**Our Case Number:** ABP-319023-24

**Re:** Combined Cycle Gas Turbine and Open Cycle Gas Turbine Thermal Power Plant, Electricity Grid Connection including 2 no. substations, and associated buildings, plant, site works, service and ancillary development on land within the townlands Knockdrin, Derrygreenagh, Derryarkin, Derryiron, Ballybeg, Coolcor, Barrysbrook, Clonin, Togher and Coole, Co. Offaly. ([www.derrygreenaghpowerplanning.ie](http://www.derrygreenaghpowerplanning.ie))

# Derrygreenagh Power Submission

**Cllr Liam Quinn**

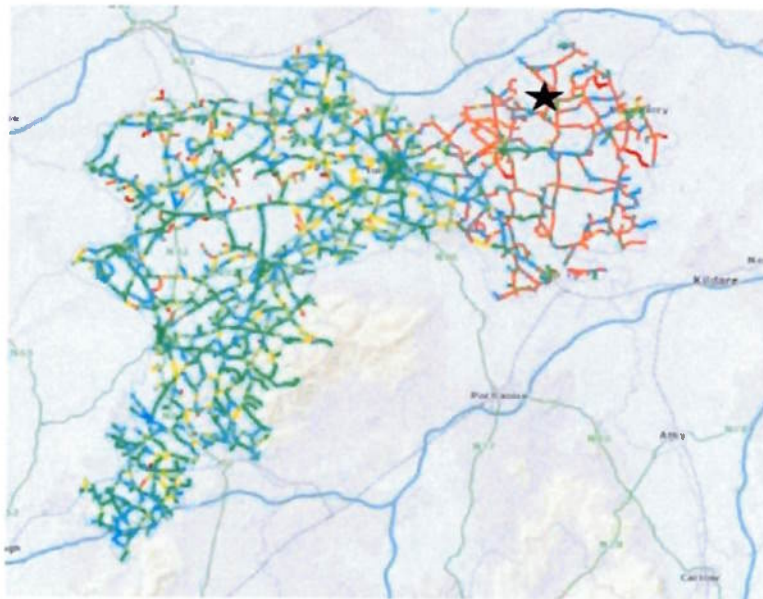
The site is accessed Via the R400. This road is constructed on a **peat foundation** and is consistently in **poor** condition. Being a road over peat; several accidents occur along this road each year when HGVs move off the road edge onto the adjoining peatlands.

The bridge over the Yellow River on the R400 failed in July 2023 and this regional road was closed for almost 5 months while a new bridge was installed. This was one of two such masonry arch bridges located on the R400, on the haul route identified for this project.

The closure of the R400 last Autumn caused significant damage to the local roads that were being used as diversion routes over this time. No upgrading works have been carried out on these roads to date.

2. A **pavement/structural survey of the R400 and L1010** be carried out and works completed in advance of any construction taking place.

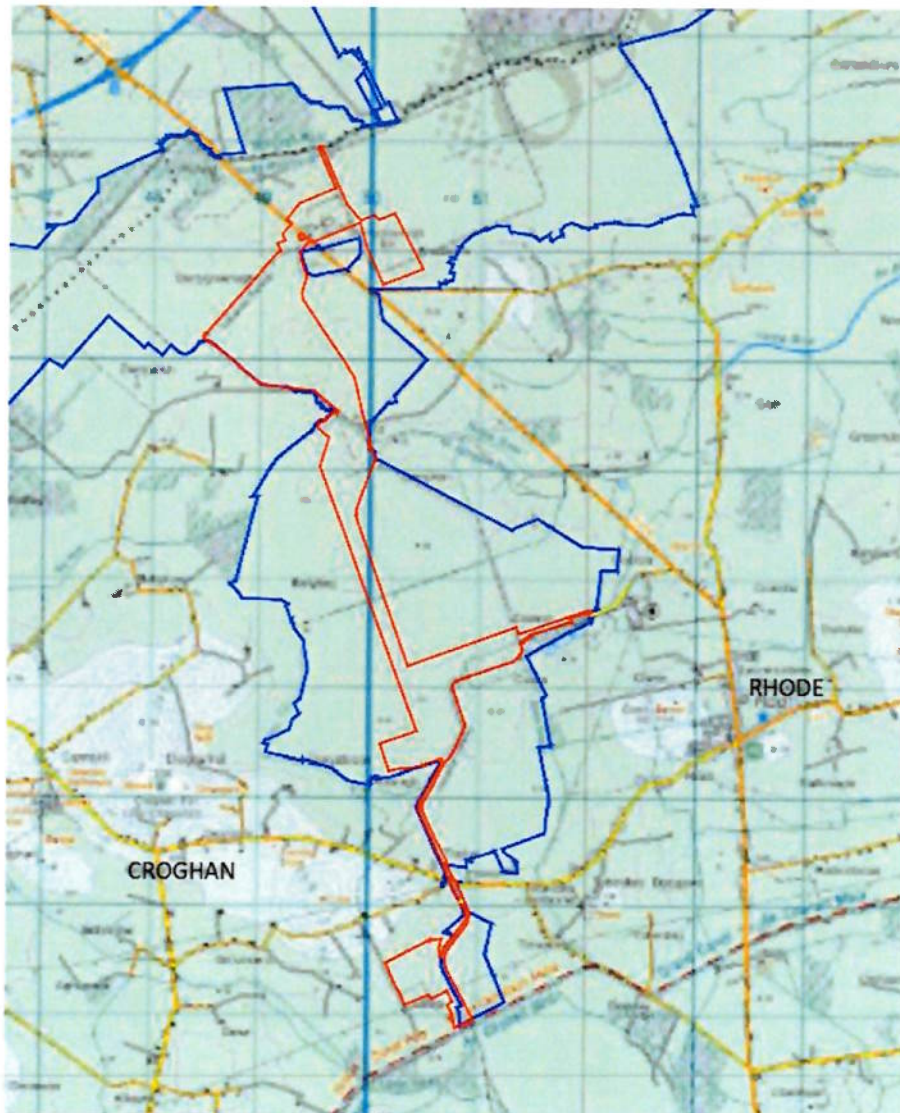
In their application BNM state that they intend to operate a Community Benefit Fund for 5 Years with a contribution of €90,000 per year. While I acknowledge this is a good will gesture, as it is not a requirement under the current RESS guidelines, I do believe the fund should be larger and run for the lifetime of the development. The monies earmarked for this fund should be index linked to output as is best practice under the current RESS Scheme. To put this development in context, County Offalys largest Windfarm “Yellow River” is located adjacent to this site and has a Community benefit fund of Circa €595,000 per annum.

**This Proposed Power Station will generate 6 times more power than Yellow River Windfarm yet contribute 85% less in Community Funding Per Annum.**

6. The proposed **Community Benefit Fund be index linked** to output as is currently best practice for Wind/Solar developments under the current RESS Guidelines. (Currently €2/MWh)

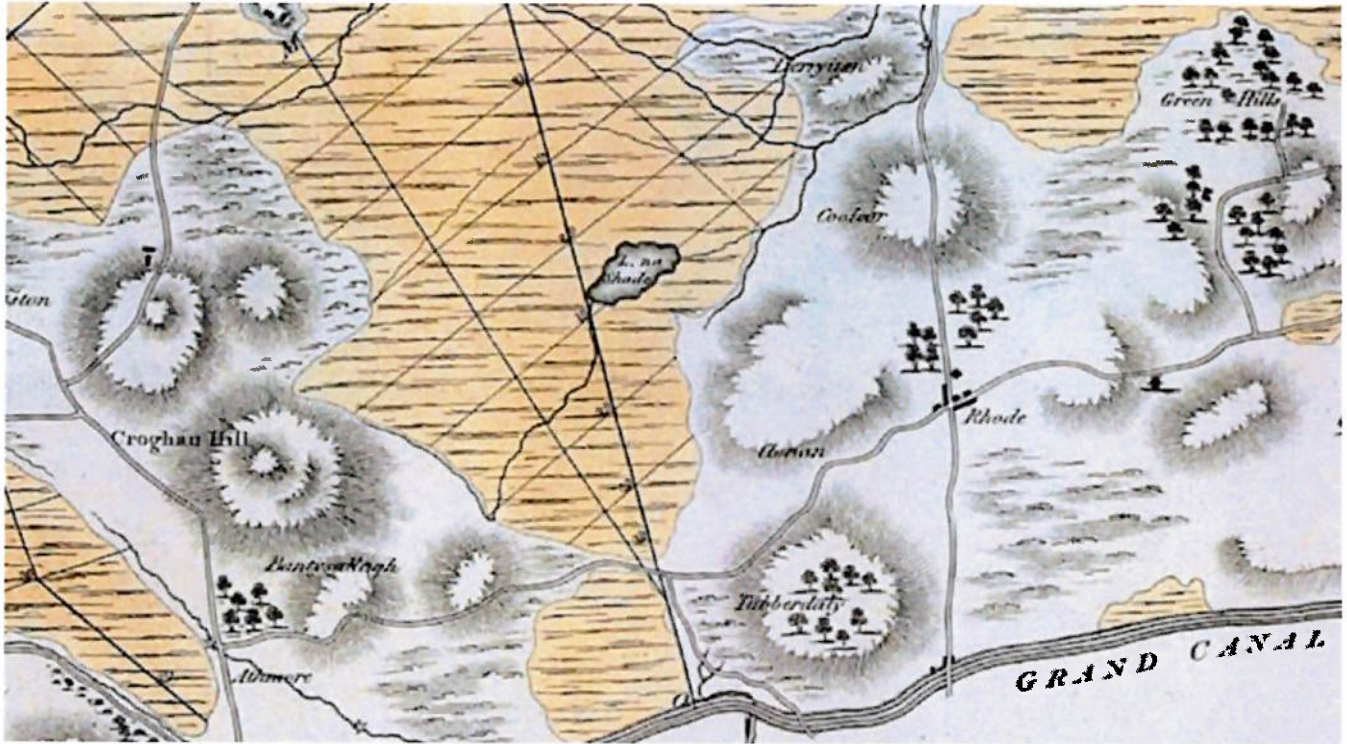
Over the past year a lot of effort has been made to have the Greenway extended to Croghan and onto the existing Greenway Trails in Westmeath. Much of this route was earmarked along the disused light rail line.

The Cable way associated with this development now proposed to utilise this rail line also. The construction of the Greenway route along this line should be included as part of the post construction remediation work.

8. The **Greenway** joining the Grand Canal to Croghan Hill and linking onto Westmeath be constructed along the route of the old Light Rail Network.
